Well Name: STERLING SILVER 33 FED	Well Location: T23S / R31E / SEC 33 / NESE / 32.2590824 / -103.777363	County or Parish/State: EDDY / NM
Well Number: 16	Type of Well: OIL WELL	Allottee or Tribe Name:
Lease Number: NMNM45236	Unit or CA Name:	Unit or CA Number:
US Well Number: 3001531091	Operator: OXY USA INCORPORATED

Notice of Intent

Type of Submission: Notice of Intent	Type of Action: Plug and Abandonment
Date Sundry Submitted: 10/08/2025	Time Sundry Submitted: 06:18
Date proposed operation will begin: 11/08/2025

NOI TO PERMANENTLY ABANDON THIS WELL VIA CEMENT PLUGGING.

CURRENT WELLBORE

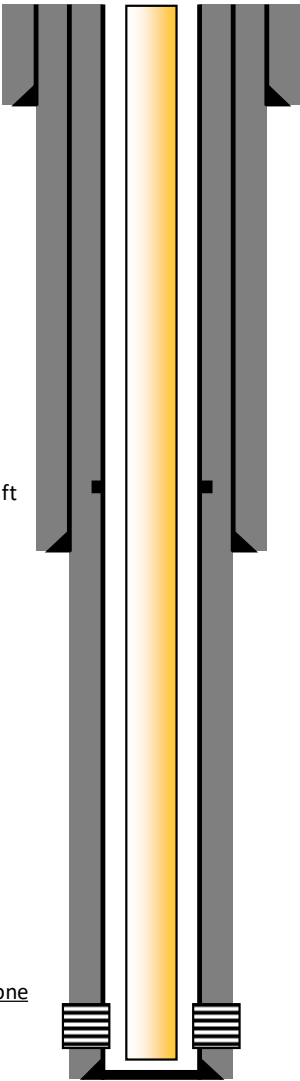
DEPTHS DEEPER THAN 7500' REQUIRE CLASS H CEMENT**APPROVED***By Keith Immatty at 11:36 am, Dec 14, 2025*FORMATION TOPS
